HALL A - TRANSVERSILITY - EXP E06-010
TARGET SYSTEM
OVEN ASSEMBLY
CS85 TOP PLATE

NO. A06010-03-04-1204

REV. C

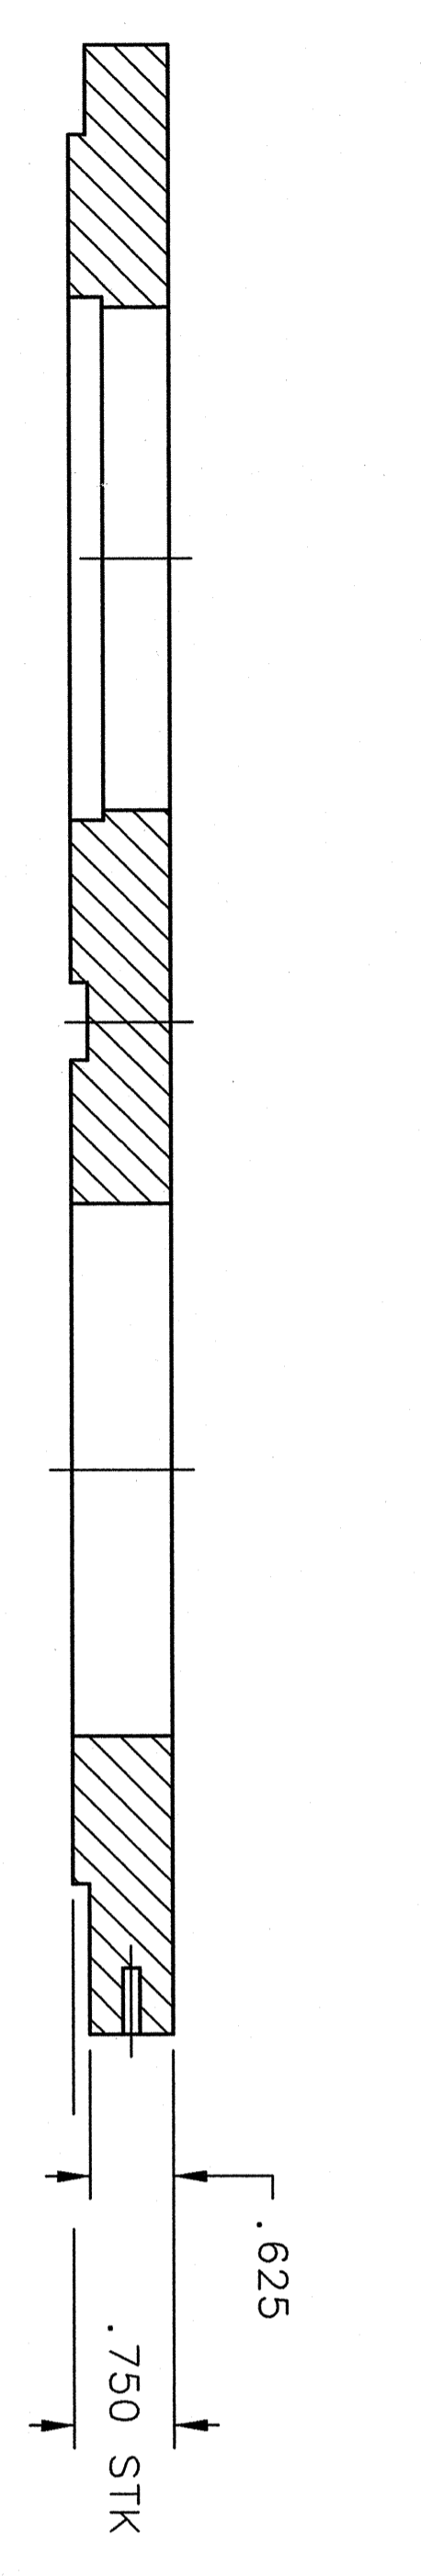
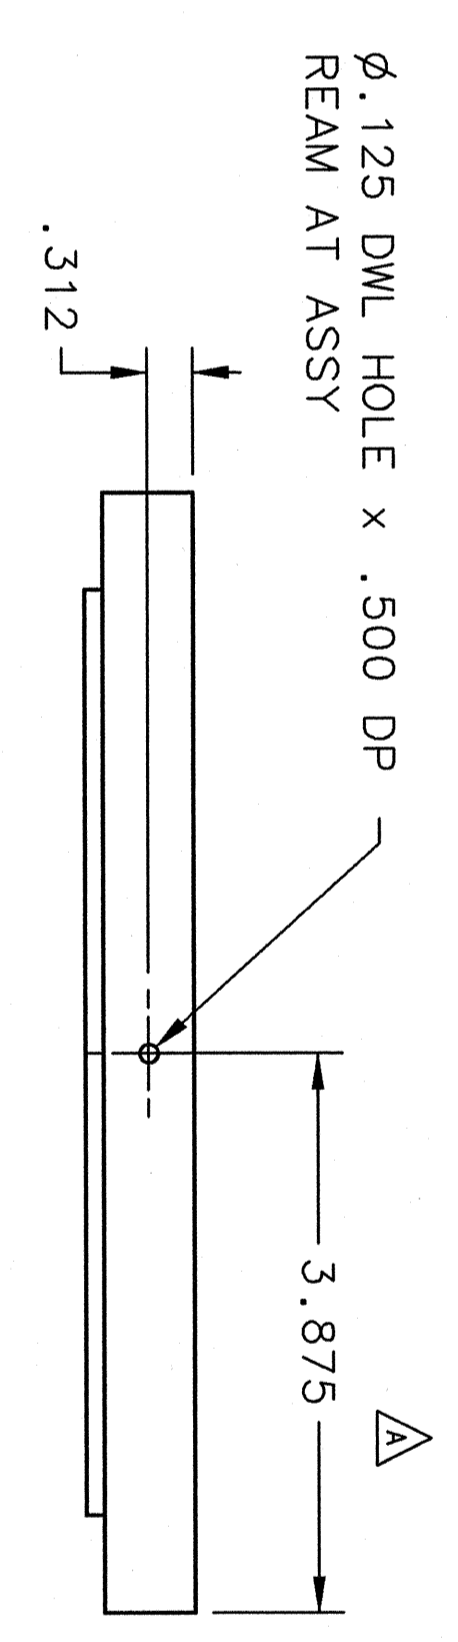
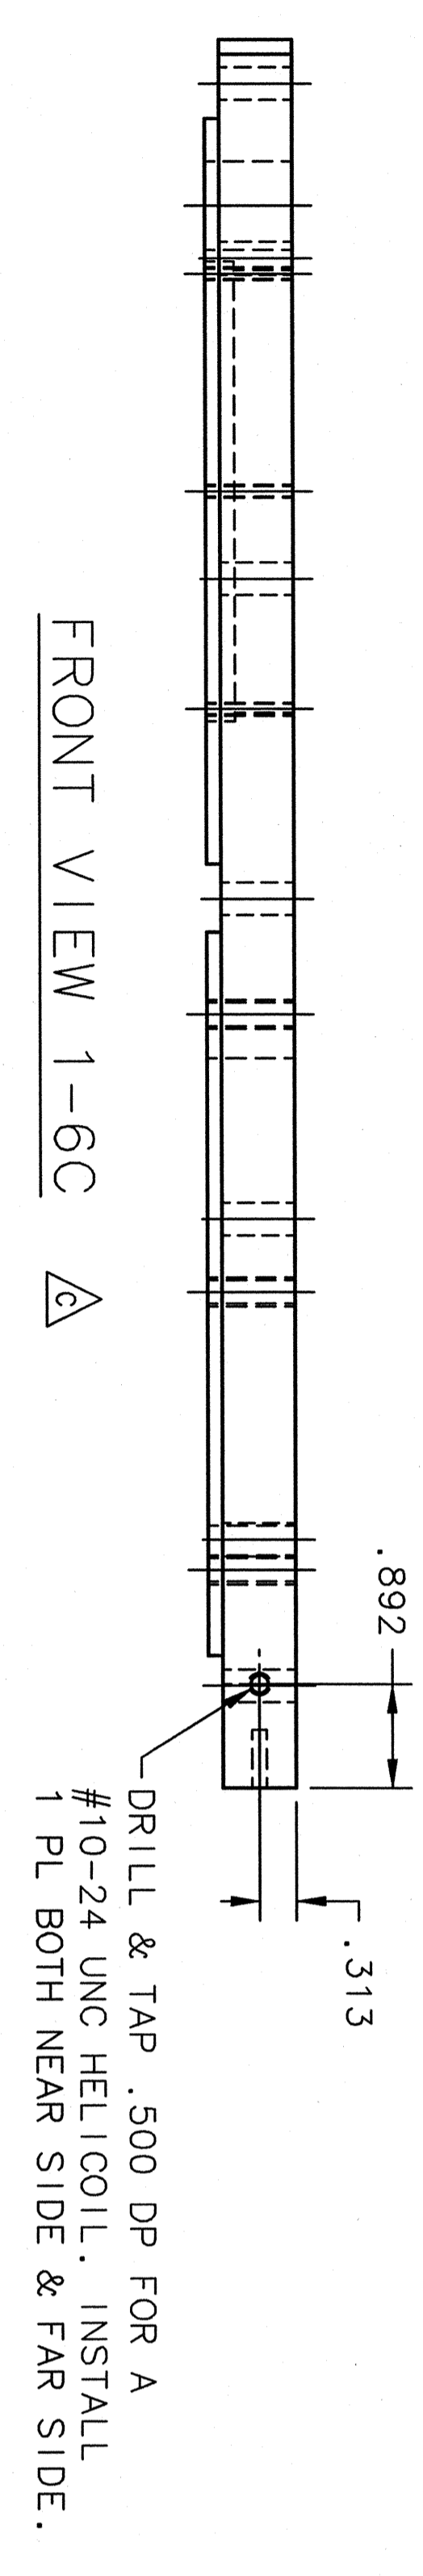
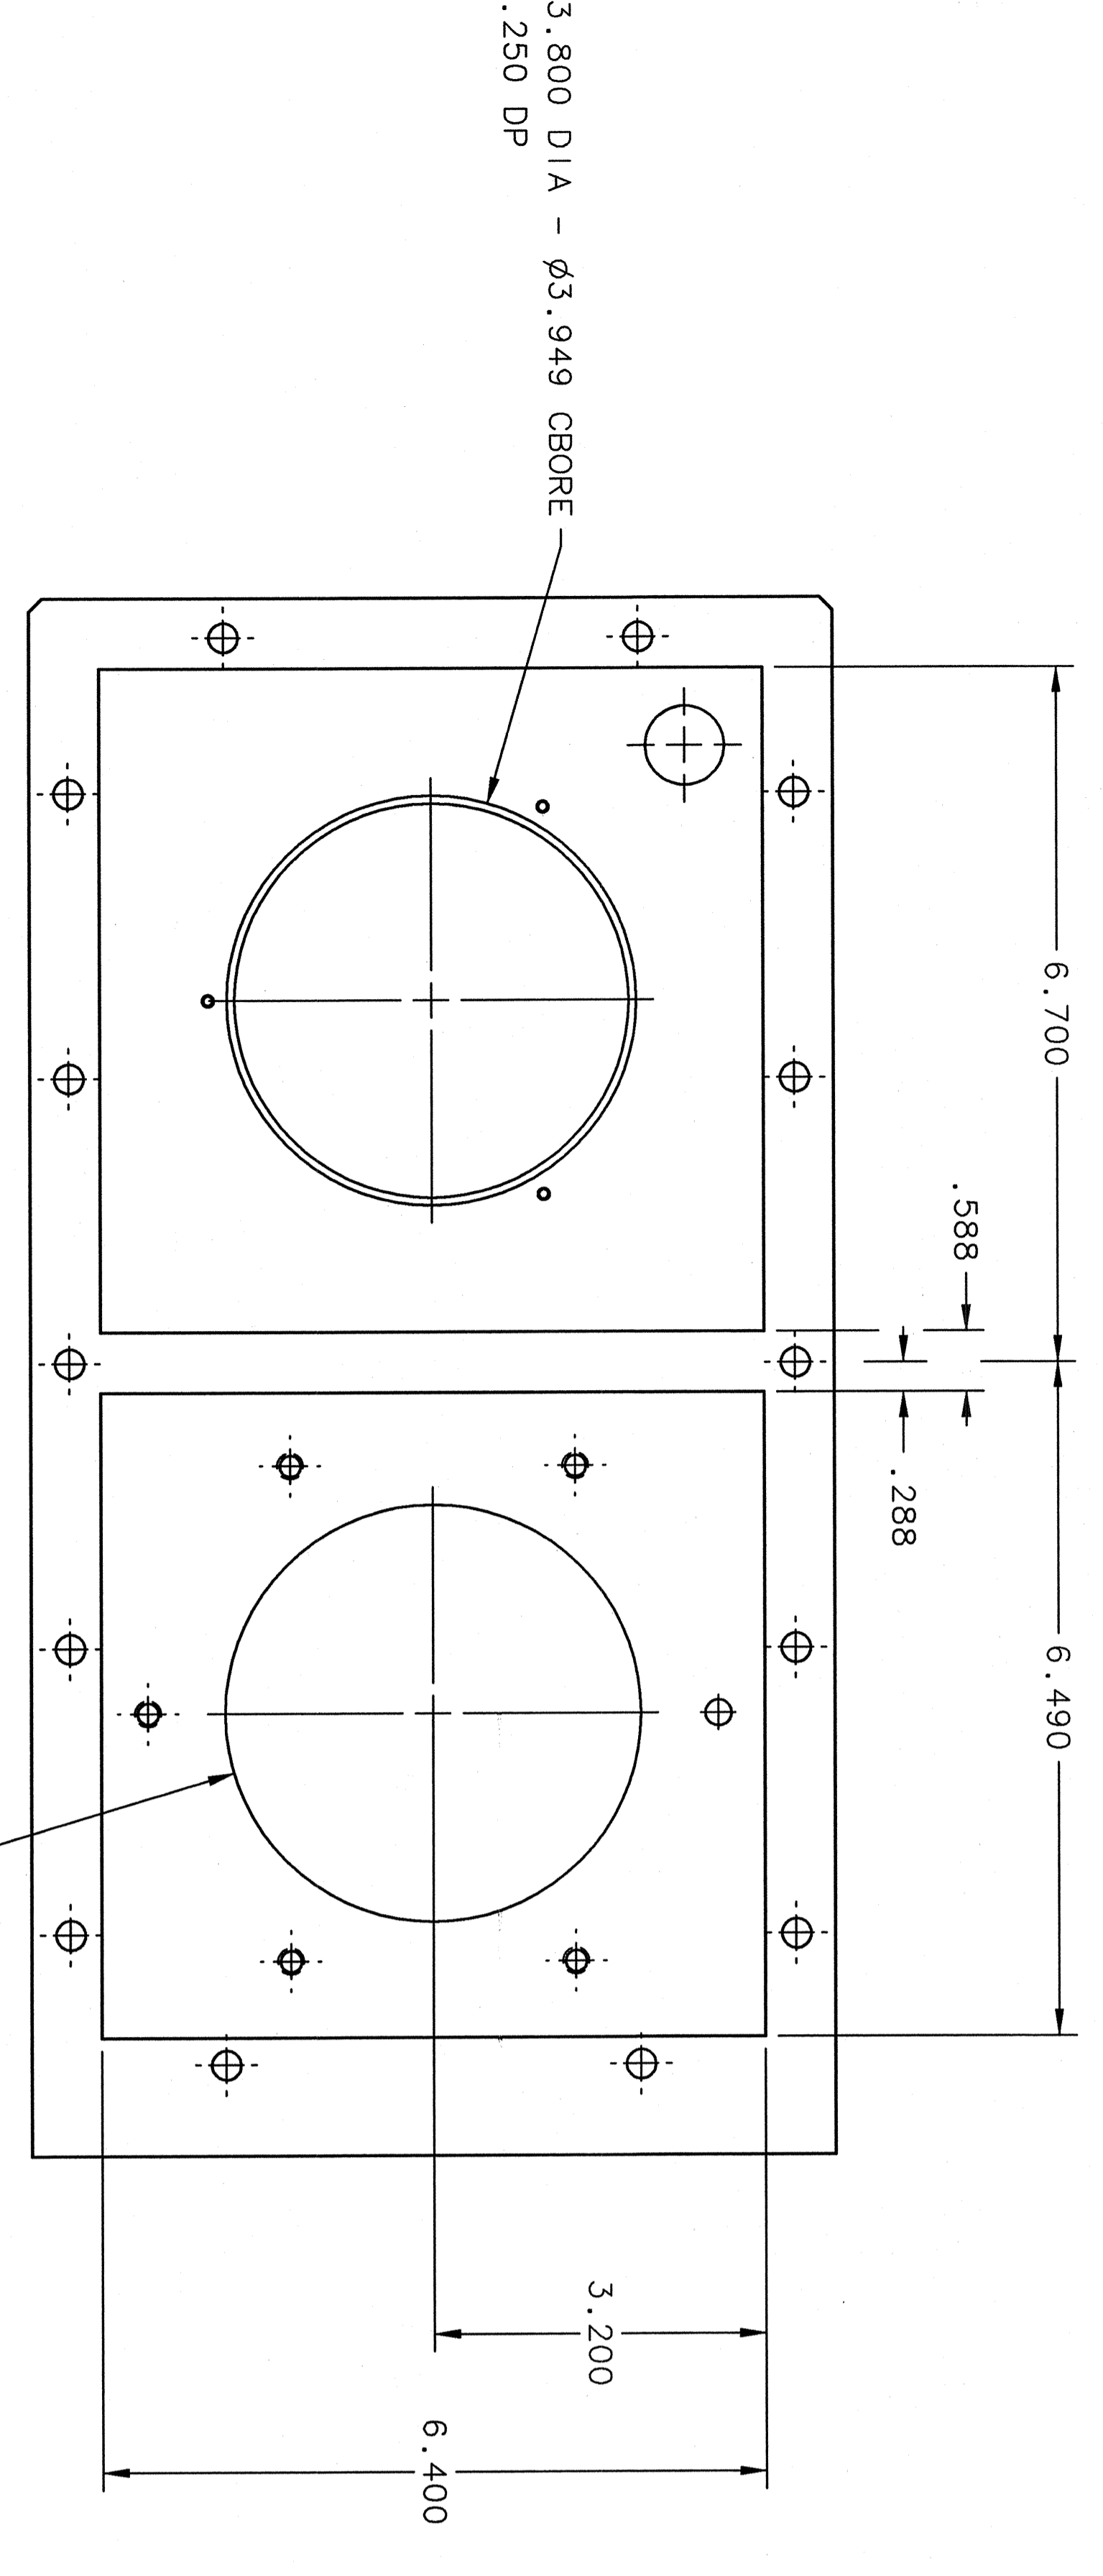
ZONE	REV	DESCRIPTION	DATE	APPROVED
1-8H	A	ADDED #4-40 UNC HELICOILS (3 PL)	17 AUG 07	SME
1-8G		14x Ø.125 THRU WAS Ø.281 THRU	21 AUG 07	AWG
1-8H		DIM 14.88 WAS 13.00		
1-8H		ADDED 1/4-20 UNC HELICOILS (5 PL)		
1-4G		DIM 7.50 WAS 7.75, DIM 3.75 WAS 3.875		
1-3D		DIM 3.750 WAS 3.875		
1-3D		ADDED NOTE 1.		
ALL		PART NAME WAS CHANGED FROM Z TOP PLATE	28 NOV 07	SME
		TO CS85 TOP PLATE.	07 DEC 07	AWG
1-5H		MATERIAL CHG FROM ALUMINA-SILICA Z-500		
1-8H		TO CS85 STRUCTURAL INSULATION,		
1-8H		REMOVED NOTE 1. HELICOIL - NITRONIC 60		
1-8G		INSERT. HELICOILS ARE NO LONGER REQUIRED		
1-6H		14 x Ø.281 THRU WAS Ø.221 THRU		
1-6H		DIM 15.00 WAS 14.88		
1-4G		DIM 7.75 WAS 7.50, DIM 3.875 WAS 3.750	06 AUG 08	SME
1-8H		DRILL & TAP 3 PL WAS .438 DP CHANGED TO		
1-8F		A THRU HOLE TO ALLOW THE ERR COIL TO		
1-8F		SUSPEND INSIDE THE OVEN BY TAPERED RODS.		
1-8F		TWO CORNERS OF THIS PLATE WERE CHAMFERED		
1-6C		.125 x 45° TO AVOID INTERFERENCE WITH

1-6C		THE RODS USED TO GIVE THE OVEN ADJ. SPT.		
1-5H		ADDED TOP VIEW 1-6C TO SHOW A #10-24 UNC		
1-5H		x .500 DP TAPERED HOLE ADDED TO BOTH FRONT		
1-5H		AND BACK SIDES.		
1-5H		NITRONIC 60 HELICOILS WERE ADDED BACK IN		
1-5H		THE DESIGN.
